**GC0111 FAST FAULT CURRENT INJECTION DRAFT LEGAL TEXT**  
**DATED 1326 FEBRUARY 2019**  
**EXTRACTS FROM ECC'S**

Figure ECC.6.3.15.9(b)

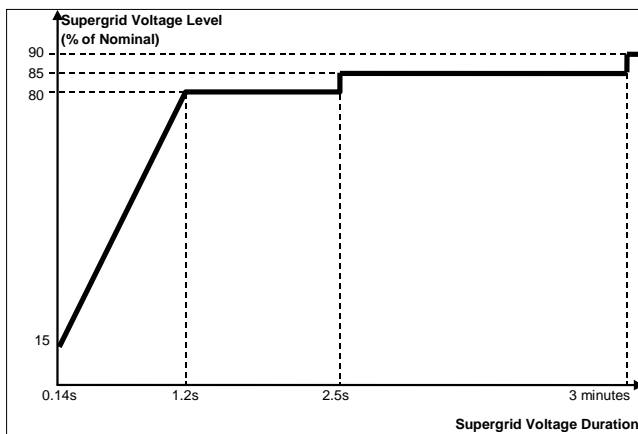
- (ii) ~~be required to satisfy the requirements of ECC.6.3.16, provide Active Power output at the Grid Entry Point or in the case of an OTSDUW, Active Power transfer~~

capability at the **Transmission Interface Point**, during **Supergrid Voltage** dips on the **Onshore Transmission System** as described in Figure ECC.6.3.15.9(b), at least in proportion to the retained balanced voltage at the **Onshore Grid Entry Point** (for **Onshore Power Park Modules**) or **Interface Point** (for **OTSDUW Plant and Apparatus and Offshore Power Park Modules**) (or the retained balanced voltage at the **User System Entry Point if Embedded**) except in the case of a **Non-Synchronous Generating Unit** or **OTSDUW Plant and Apparatus** or **Power Park Module** where there has been a reduction in the **Intermittent Power Source** or in the case of **OTSDUW Active Power** transfer capability in the time range in Figure ECC.6.3.15.9(b) an allowance shall be made for the fall in input power and the corresponding reduction of real and reactive current that restricts the Active Power output or in the case of an OTSDUW Active Power transfer capability below this level.

- (iii) restore **Active Power** output (or, in the case of **OTSDUW, Active Power** transfer capability), following **Supergrid Voltage** dips on the **Onshore Transmission System** as described in Figure ECC.6.3.15.9(b), within 1 second of restoration of the voltage to 0.9 pu of the nominal voltage at the:

to the minimum levels specified in ECC.6.1.4 to at least 90% of the level available immediately before the occurrence of the dip except in the case of a **Non-Synchronous Generating Unit, OTSDUW Plant and Apparatus** or **Power Park Module** where there has been a reduction in the **Intermittent Power Source** in the time range in Figure ECC.6.3.15.9(b) that restricts the **Active Power** output or, in the case of **OTSDUW, Active Power** transfer capability below this level. Once the **Active Power** output or, in the case of **OTSDUW, Active Power** transfer capability has been restored to the required level, **Active Power** oscillations shall be acceptable provided that:

Figure ECC.6.3.16(a)

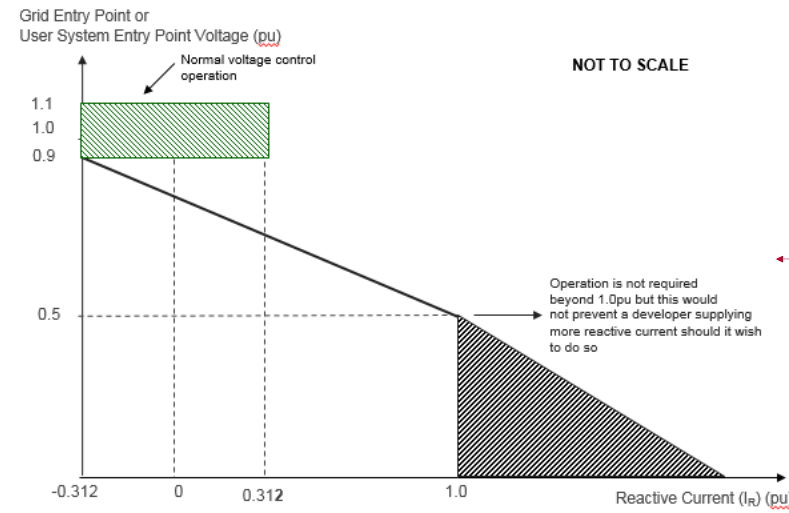
For any balanced or unbalanced fault which results in the positive phase sequence voltage falling below the voltage levels specified in ECC.6.1.4 phase voltage on one or more phases falling outside the limits specified in ECC.6.1.2 at the Grid Entry Point or User System Entry Point (if Embedded), each Type B, Type C and Type D Power Park Module or each Power Park Unit within a Type B, Type C and Type D Power Park Module or HVDC Equipment shall, as a minimum (unless an alternative type registered solution has unless otherwise been agreed with The Company), be required to inject a reactive current above the heavy black line shaded area shown in Figure ECC.16.3.16(a) and Figure 16.3.16(b). For the purposes of this requirement, the maximum rated current is taken to be the maximum current each Power Park Module (or constituent Power Park Unit) or HVDC Converter is capable of supplying when operating at rated Active Power and rated Reactive Power (as required under ECC.6.3.2) at a nominal voltage of 1.0pu. For example, in the case of a 100MW Power Park Module the Rated Active Power would be taken as 100MW and the rated Reactive Power would be taken as 32.8MVAr (ie Rated MW output operating at 0.95 Power Factor lead or 0.95 Power Factor lag as required under ECC.6.3.2.4). For the avoidance of doubt, where the phase voltage at the Grid Entry Point or User System Entry Point is not zero, the reactive current injected shall be in proportion to the retained voltage at the Grid Entry Point or User System Entry Point but shall still be required to remain above the shaded area in Figure 16.3.16(a) and Figure 16.3.16(b).

ECC.6.3.16.1.3 Figure ECC.6.3.16(a) defines the reactive current ( $I_R$ ) to be supplied under a faulted condition which shall be dependent upon the pre-fault operating condition and the retained voltage at the Grid Entry Point or User System Entry Point voltage. For the avoidance of doubt, each Power Park Module (and any constituent element thereof) or HVDC Equipment, shall be required to inject a reactive current ( $I_R$ ) which shall be not less than its pre-fault reactive current and which shall as a minimum increase with the retained voltage each time the retained voltage at the Grid Entry Point or User System Entry Point (if Embedded) falls below 0.9pu whilst ensuring the overall rating of the Power Park Module (or constituent element thereof) or HVDC Equipment shall not be exceeded.

Figure ECC.6.3.16(b)

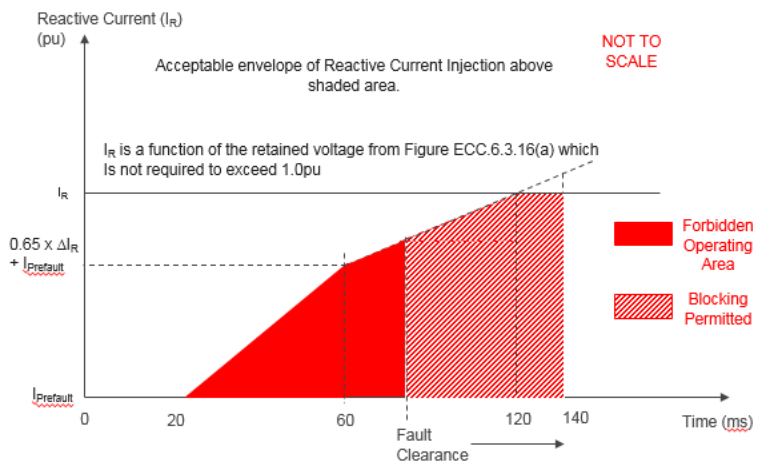
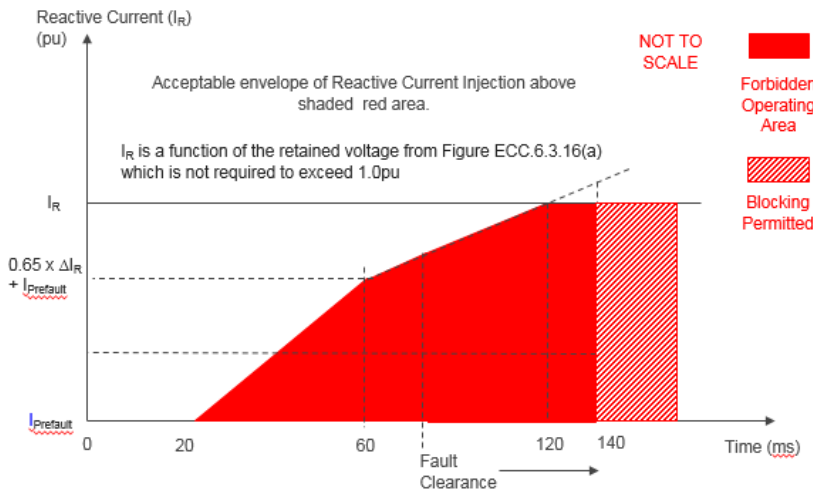
ECC.6.3.16.1.4 In addition to the requirements of ECC.6.3.16.1.2 and ECC.6.3.16.1.3, each **Type B, Type C and Type D Power Park Module** or each **Power Park Unit** within a **Type B, Type C and Type D Power Park Module** or **HVDC Equipment** shall be required to inject reactive current above the shaded area shown in Figure ECC.6.3.16(b) and Figure ECC.6.3.16(c) which illustrates how the reactive current shall be injected over time from fault inception in which the value of  $I_R$  is determined from Figure ECC.6.3.16(a). In figures ECC.6.3.16(b) and ECC.6.3.16(c)  $\Delta I_R$  is the value of the reactive current ( $I_R$ ) less the pre-fault current. In this context fault inception is taken to be when the voltage at the **Grid Entry Point or User System Entry Point** falls below 0.9pu.

ECC.6.3.16.1.5 The injected reactive current ( $I_r$ ) shall be above the shaded area shown in Figure ECC.6.3.16(b) and Figure ECC.6.3.16(c) with priority being given to reactive current injection with any residual capability being supplied as active current. Under any faulted condition, where the voltage falls outside the limits specified in ECC.6.1.4, there would be no requirement for each **Power Park Module** or constituent **Power Park Unit** or **HVDC Equipment** to exceed its transient or steady state rating of 1.0pu as defined in ECC.6.3.16.1.7.

Figure-ECC.16.3.16(a)

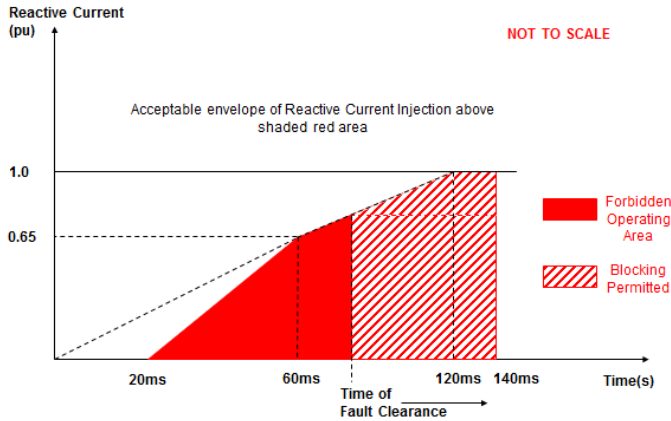
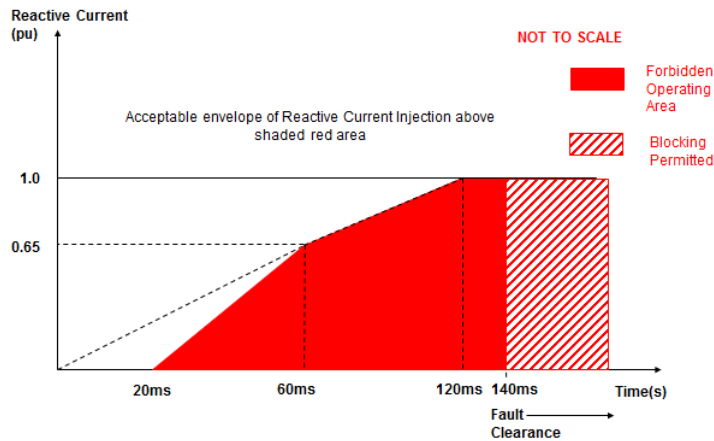
~~ECC.6.3.16.1.3~~ —The converter(s) of each **Type B, Type C** and **Type D Power Park Module** or **HVDC Equipment** is permitted to block upon fault clearance in order to mitigate against the risk of instability that would otherwise occur due to transient overvoltage excursions. Figure ECC.16.3.16(a) and Figure ECC.16.3.16(b) shows the impact of variations in fault clearance time which shall be no greater than 140ms. The requirements for the maximum transient overvoltage withstand capability and associated time duration, shall be agreed between the **EU Code User** and **The Company** as part of the **Bilateral Agreement**. Where the **EU Code User** is able to demonstrate to **The Company** that blocking is required in order to prevent the risk of transient over voltage excursions as specified in ECC.6.3.16.1.5, **EU Generators** and **HVDC System Owners** are required to both advise and agree with **The Company** of the control strategy, which must also include the approach taken to de-blocking. Notwithstanding this requirement, **EU Generators** and **HVDC System Owners** should be aware of their requirement to fully satisfy the fault ride through requirements specified in ECC.6.3.15.

Figure ECC.16.3.16(d)

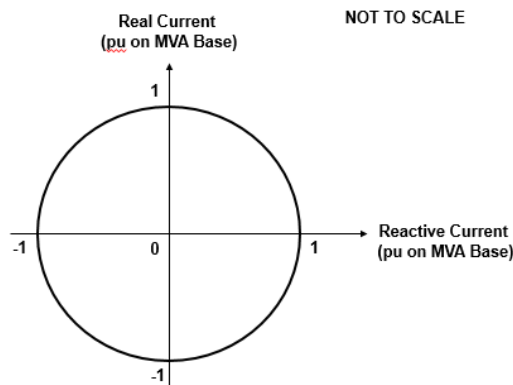
For the avoidance of doubt, the total current of 1.0pu would be assumed to be on the MVA rating of the **Power Park Module** or **HVDC Equipment** (less losses). Under all normal and abnormal conditions, the steady state or transient rating of the **Power Park Module** (or any constituent element including the **Power Park Units**) or **HVDC Equipment**, would not be required to exceed the locus shown in Figure 16.3.16(d).

Figure ECC4.1

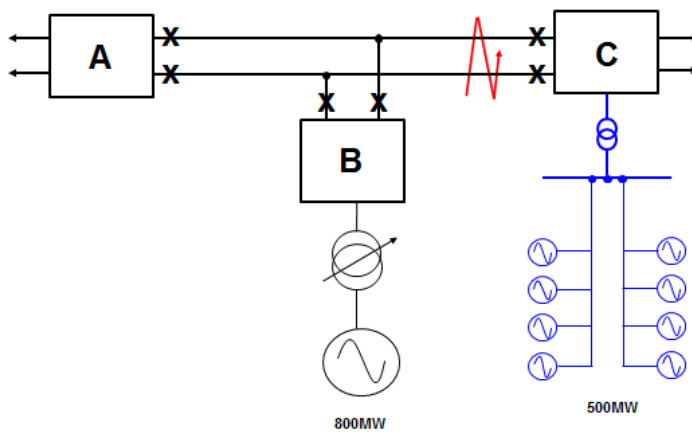
ECC.4EC1.1.1 For a voltage depression at a **Grid Entry Point or User System Point**, the **Fast Fault Current Injection** requirements are detailed in ECC.6.3.16. Figure ECC4.1 shows an example of a 500MW **Power Park Module** subject to a close up solid three phase short circuit fault connected directly connected to the **Transmission System** operating at 400kV.

Figure ECC4.2(a) – Voltage deviation at Substation C

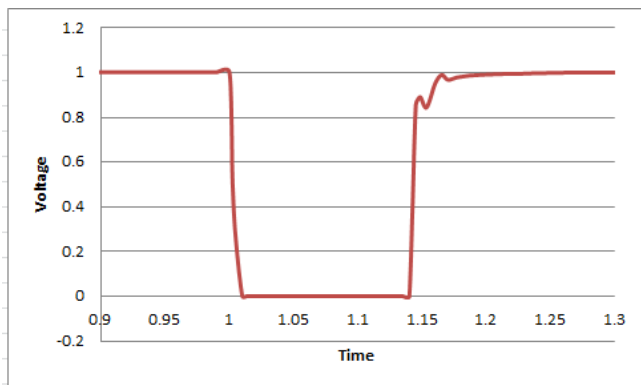
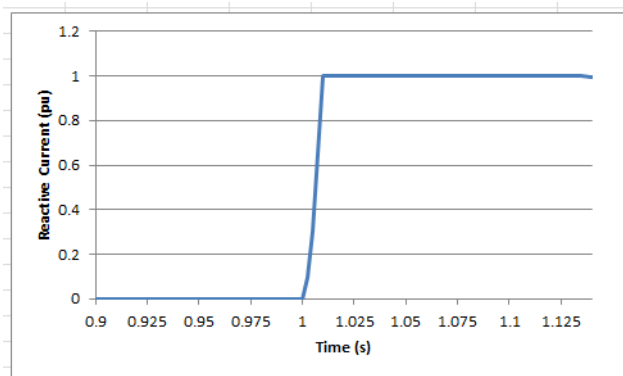
ECC.4EC1.1.2 Assuming negligible impedance between the fault and substation C, the voltage at Substation C will be close to zero until circuit breakers at Substation C open, typically within 80–100ms, subsequently followed by the opening of circuit breakers at substations A and B, typically 140ms after fault inception. The operation of circuit breakers at Substations A, B and C will also result in the tripping of the 800MW generator which is permitted under the SQSS. The **Power Park Module** is required to satisfy the requirements of ECC.6.3.16, and an example of the deviation in system voltage at the **Grid Entry Point** and expected reactive current injected by the **Power Park Module** before and during the fault is shown in Figure ECC4.2(a) and (b).

Figure ECC4.3(a)

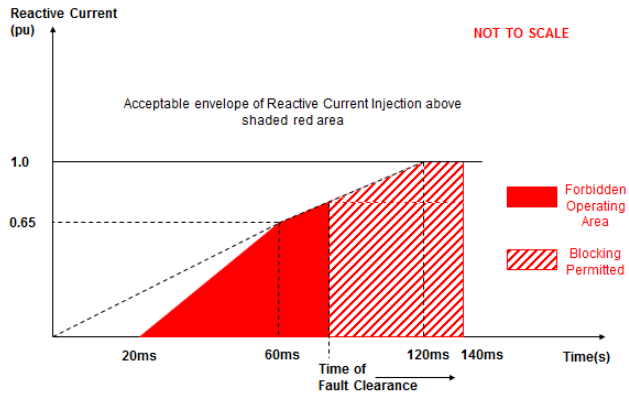
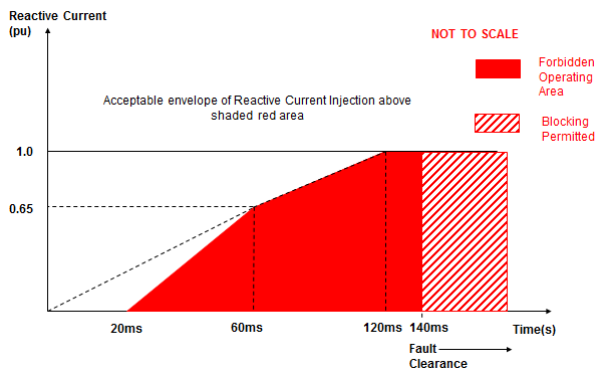
It is important to note that blocking is permitted upon fault clearance in order to limit the impact of transient overvoltages. This effect is shown in Figure ECC4.3(a) and Figure ECC4.3(b)

ECC.4EC1.1.3 So long as the reactive current injected is above the shaded area as illustrated in Figure ECC4.3(a) or ECC4.3(b), the **Power Park Module** would be considered to be compliant with the requirements of ECC.6.3.16 Taking the example outlined in ECC.4EC1.1.1 where the fault is cleared in 140ms, the following diagram in Figure ECC4.4 results.

Figure ECC4.4(a)

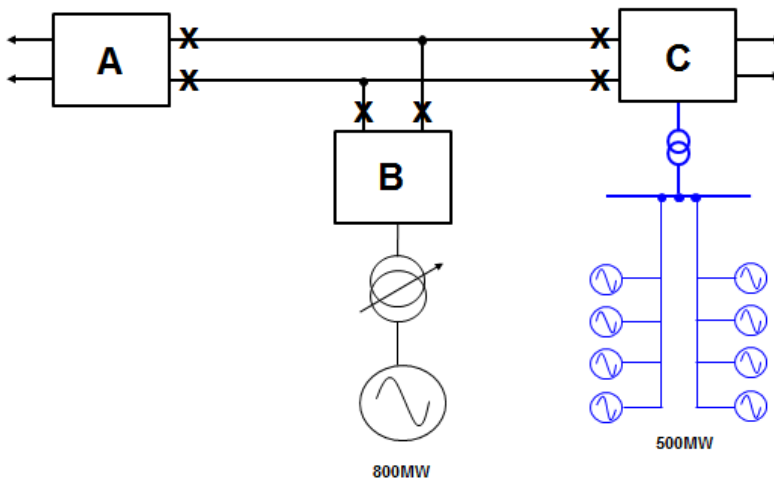
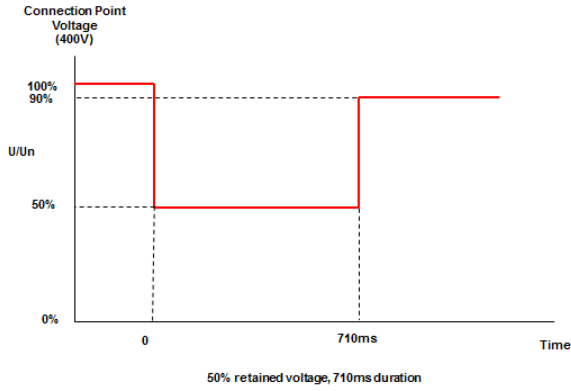
ECC.4EC1.2.1 Under the fault ride through requirements specified in ECC.6.3.15.9 (*Voltage dips cleared in excess of 140ms*), **Type B, Type C and Type D Power Park Modules** are also required to remain connected and stable for voltage dips on the **Transmission System** in excess of 140ms. Figure ECC4.4 (a) shows an example of a 500MW **Power Park Module** connected to the **Transmission System** and Figure ECC4.4 (b) shows the corresponding voltage dip seen at the **Grid Entry Point** or **User System Point** which has resulted from a remote fault on the **Transmission System** cleared in a backup operating time of 710ms.

Figure ECC4.5 Reactive Current Injected for a 50% voltage dip for a period of 710ms

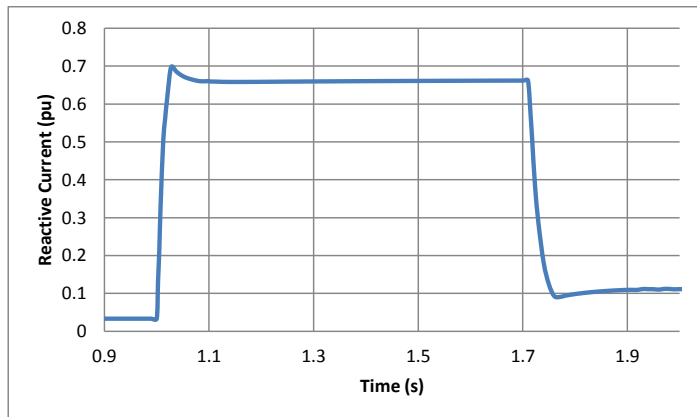
ECC.4EC1.2.1 In this example, the voltage dips to 0.5pu for 710ms. Under ECC.6.3.16 each **Type B**, **Type C** and **Type D Power Park Module** is required to inject reactive current into the **System** and shall respond in proportion to the change in **System** voltage at the **Grid Entry Point** or **User System Entry Point** up to a maximum value of 1.0pu of rated current. An example of the expected injected reactive current at the **Connection Point** is shown in Figure ECC4.5
